**TOWN OF BAY HARBOR ISLANDS
MORRIS N. BROAD COMMUNITY CENTER
1175 95TH STREET
BAY HARBOR ISLANDS, FL 33154**

DEVELOPMENT & REVIEW COMMITTEE MEETING

**TOWN OF BAY HARBOR ISLANDS
COMMUNITY DEVELOPMENT
MEMORANDUM**

Subject: Site Development Plan Application
New Multi-Family Residential Development (9 DU)
Applicant - 1160 101 St. Bay Harbor Condo 2618, LLC
1160 101st Street
Bay Harbor Islands Acct. No. SPR2023-000036
MMPA Acct. No. 01-0702-1178

LANDSCAPE PLAN

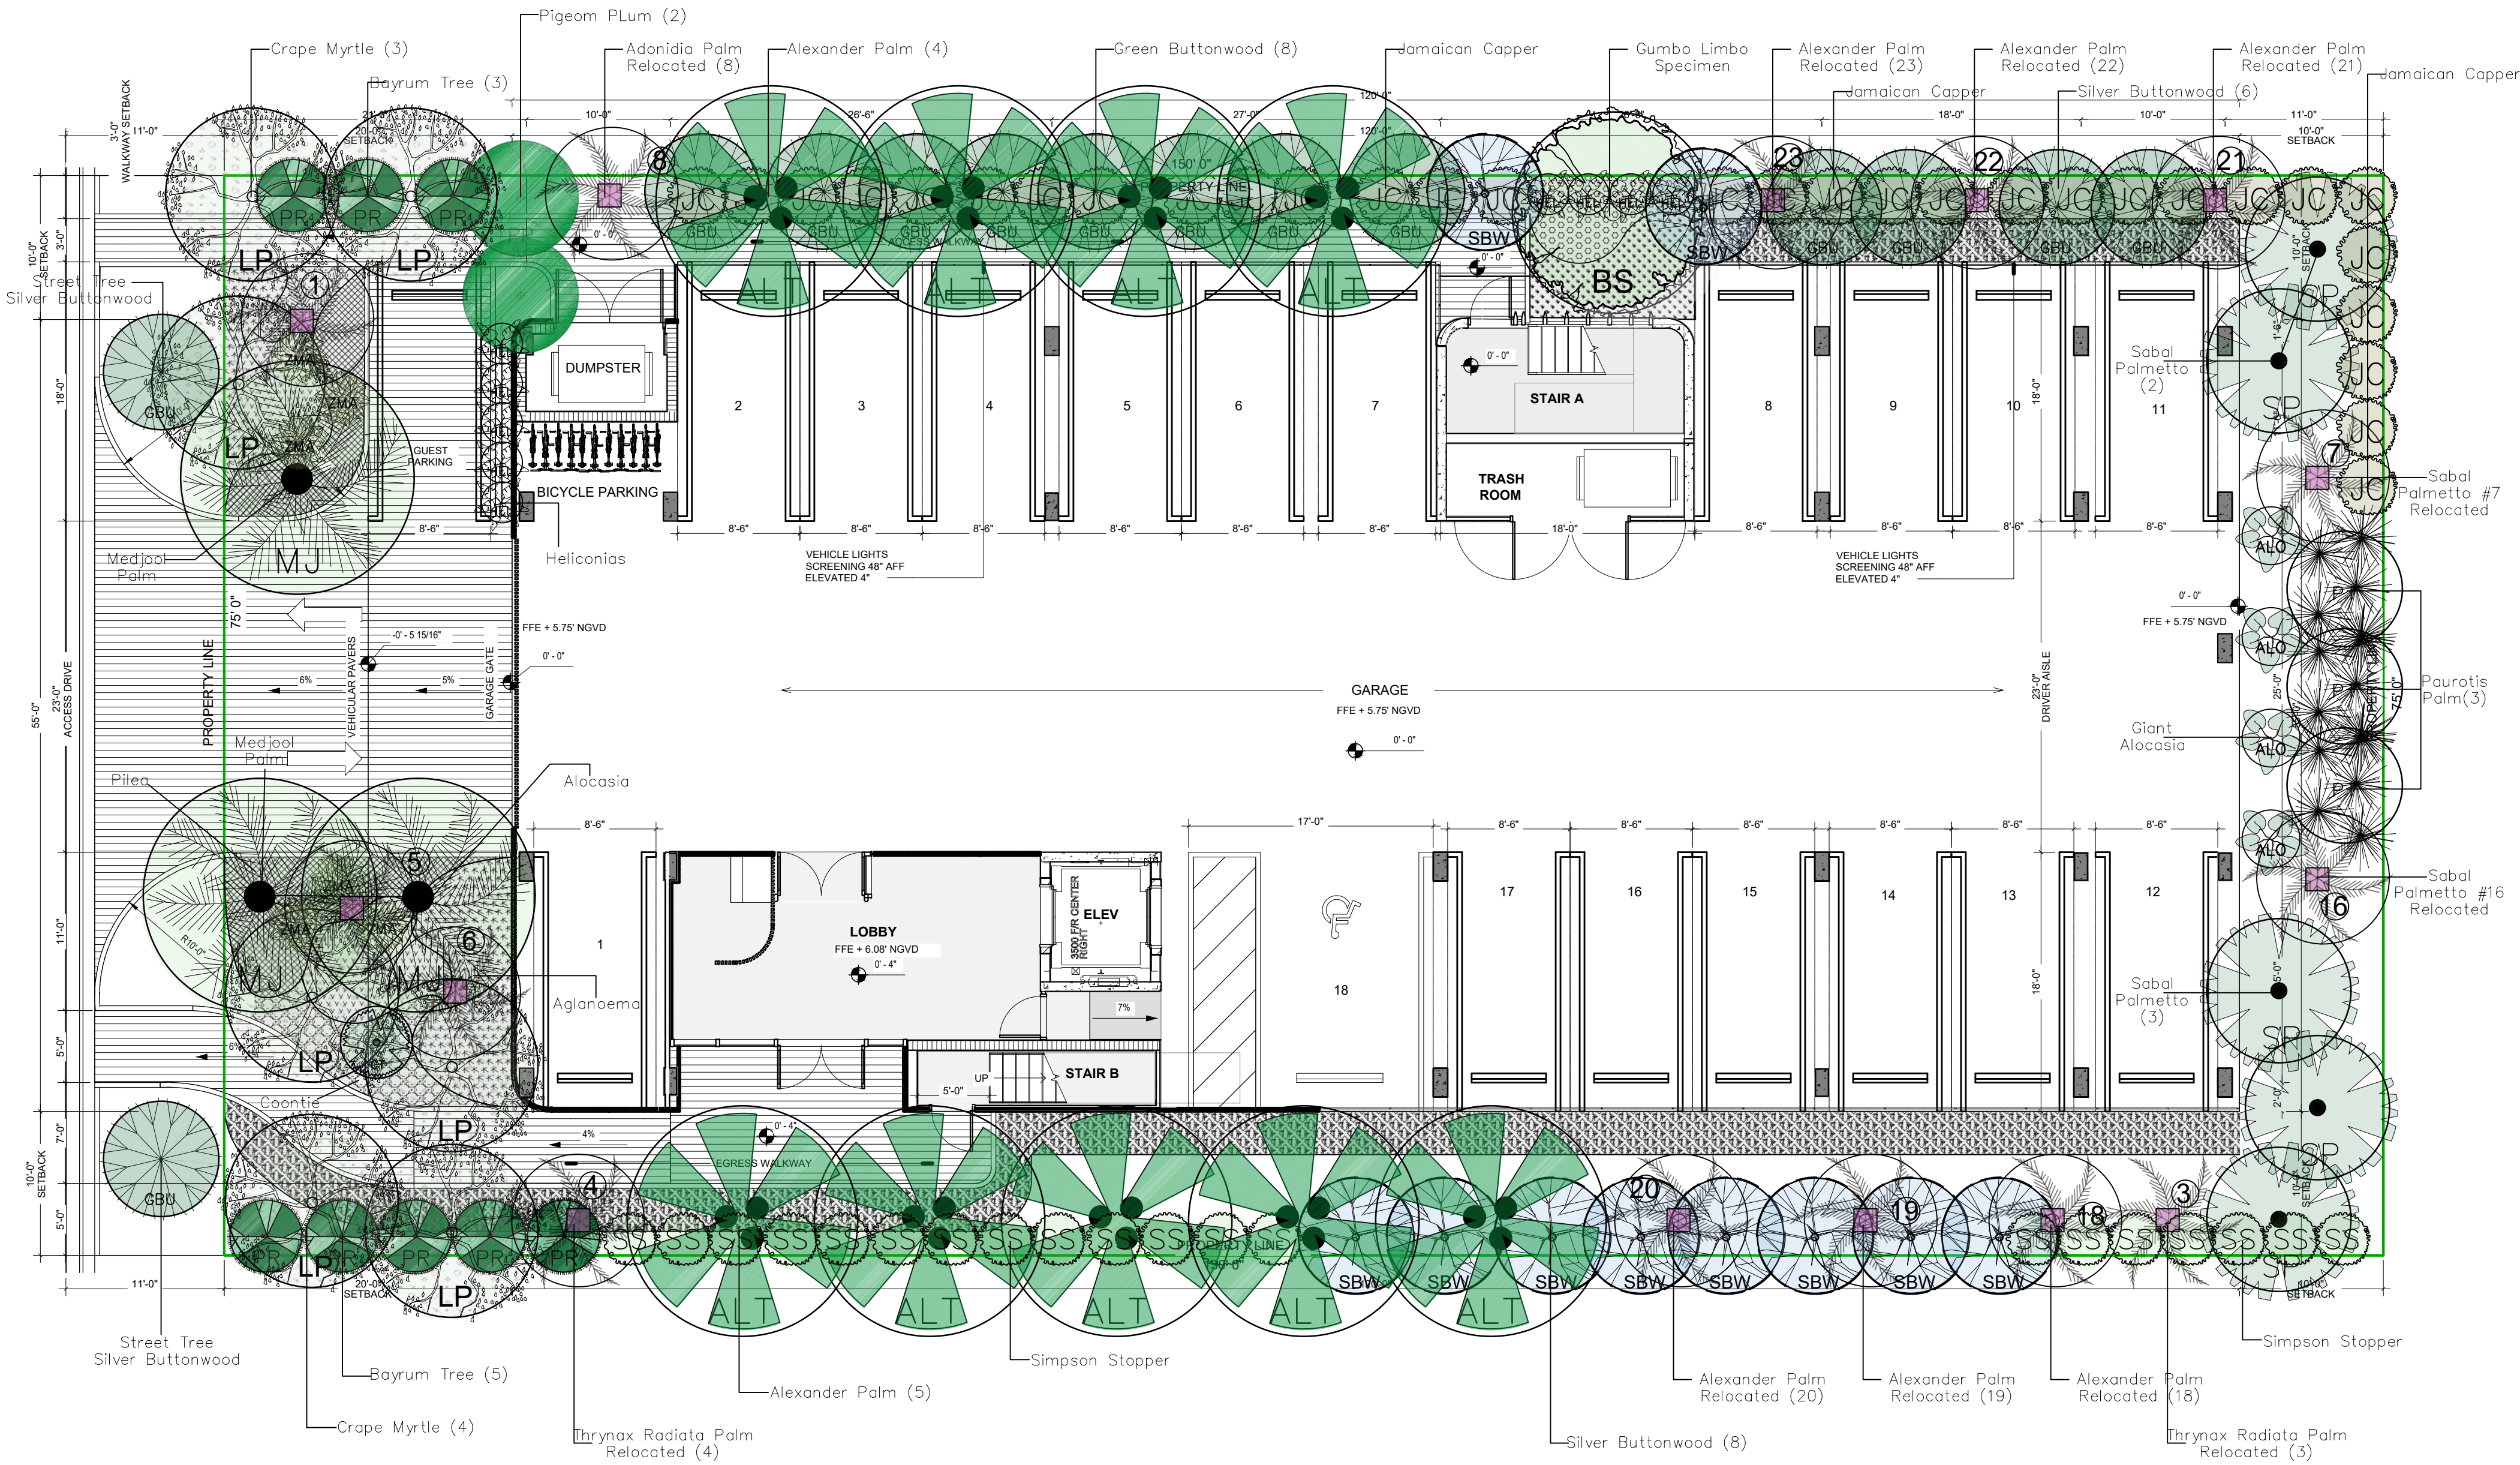
- 16) The Landscape Plan needs the following corrections:
 - a. Backflow preventer / FDC is required to be screened from view on three (3) sides to allow access but screen the facility.

- b. Street Trees - The Town's required Street Tree species for 101st Street is a Green Buttonwood. The Landscape Table shows Green Buttonwood, but the plan shows Silver Buttonwoods. Also, the minimum Town Street Tree size is 15' hgt. x 6' spread x 2.5" trunk caliper at time of planting. The plan shows 14' hgt.

TREE SURVEY

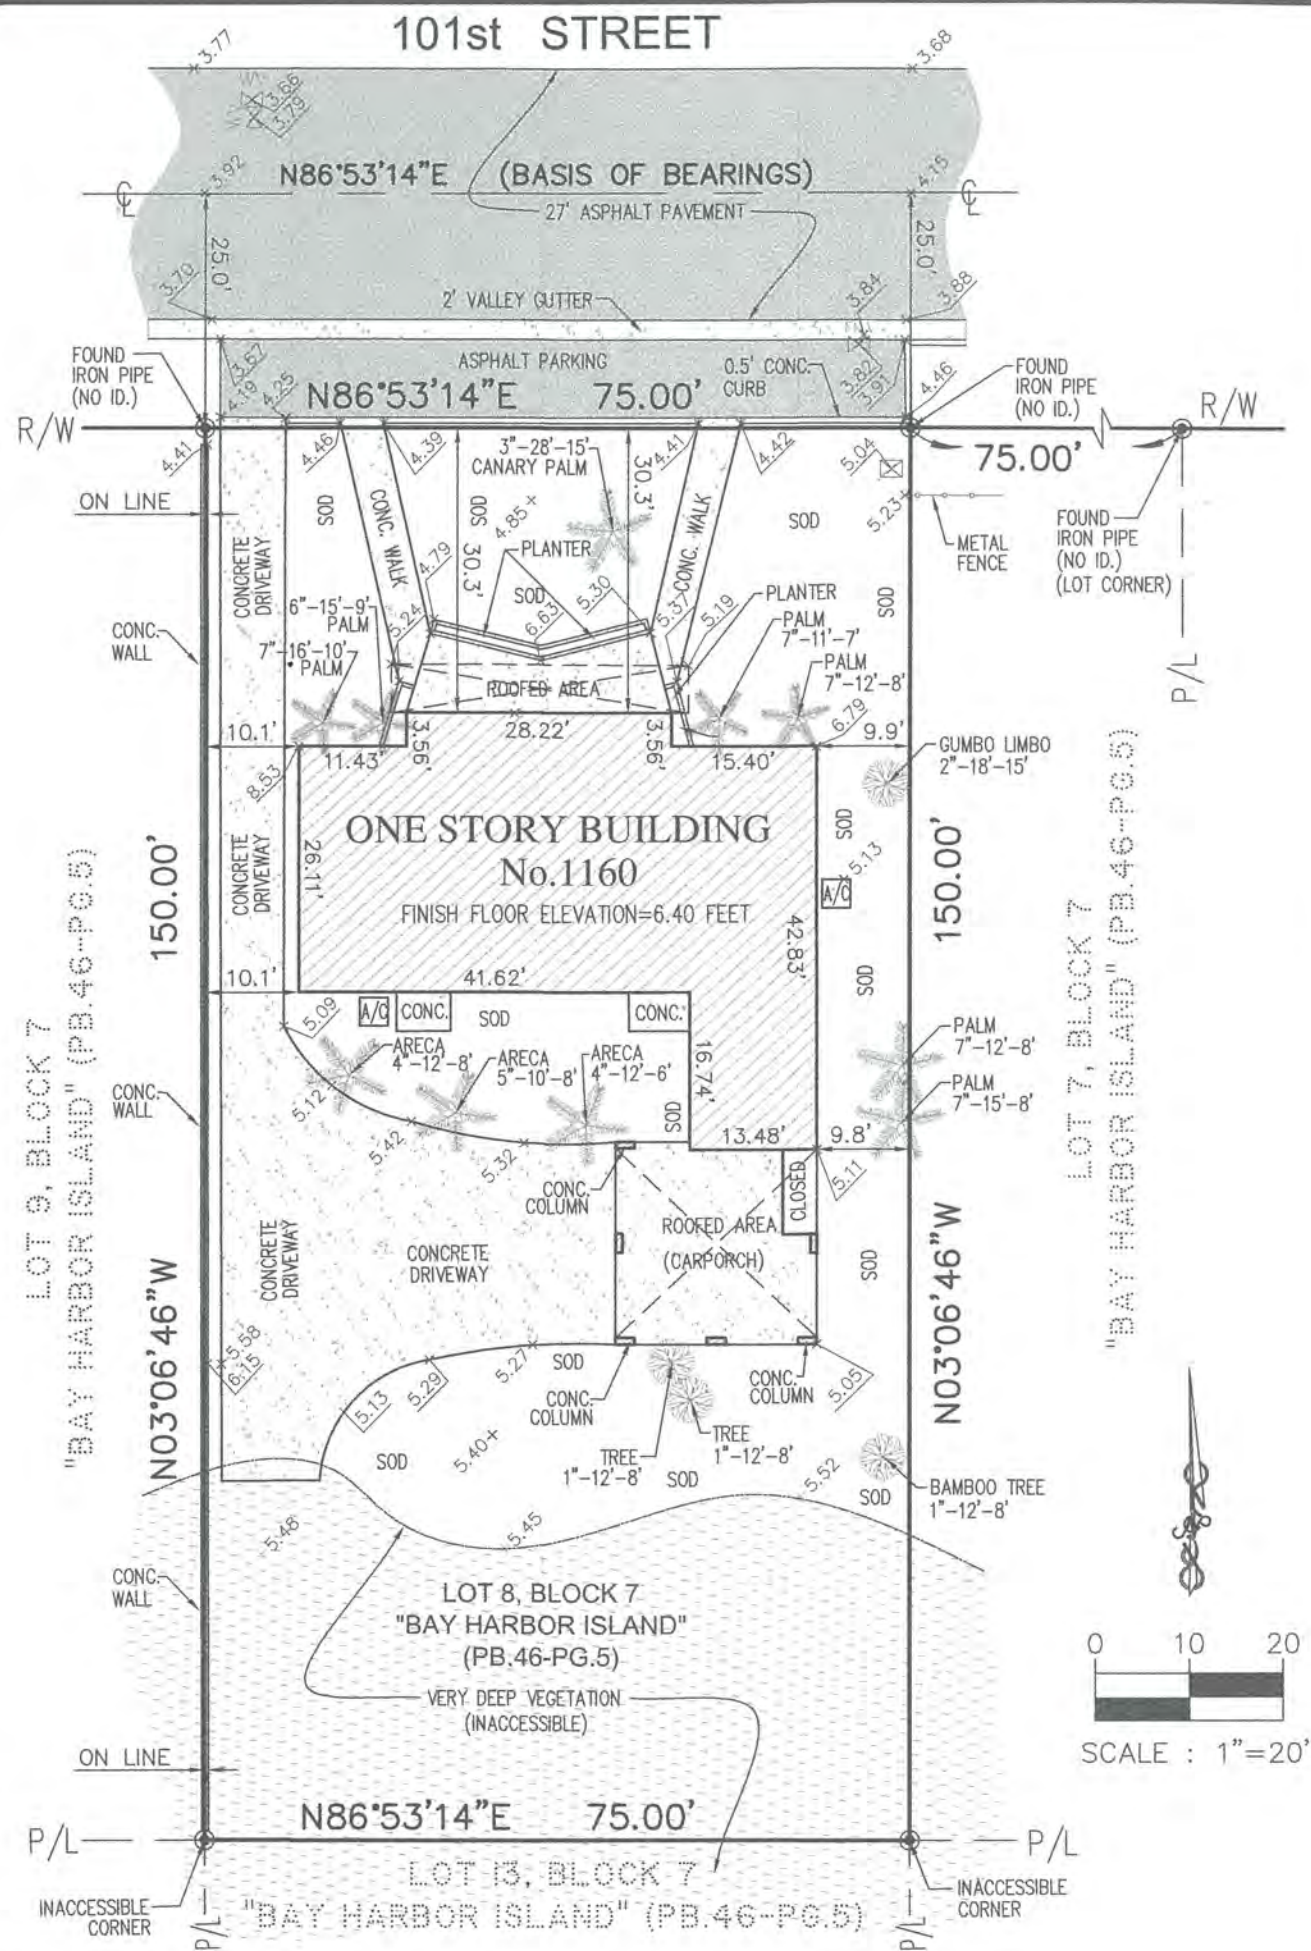
- 1) A tree survey of existing trees is a requirement for development approval. A tree survey was provided; however, the scale must be the same as the site plan and included an index of the tree species / sizes / conditions. There is a Tree Disposition Plan as part of the Landscape Plans, but it is unknown how the specific tree information was obtained.
